## CHASSIS FRAME RAIL COATING

### OVERVIEW

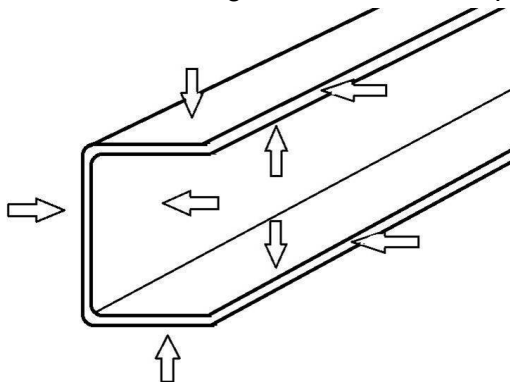
The Sales Department would like to inform the dealer network that Sutphen is continuing to strengthen its frame rails and combat corrosion by bolstering its already renowned frame rails. Sutphen will now apply Cathacoat, Primer, a Top Paint Coat and a layer of Raptor Texture Coating. To the frame rail area where pump modules are positioned on the chassis. This will be the new standard process moving forward.

The Raptor Texture Coat will not only act as another layer of frame rail protection, but it will also add additional resistance which helps inhibit pump module movement.

Reference the images below for the Raptor Texture Coating application.
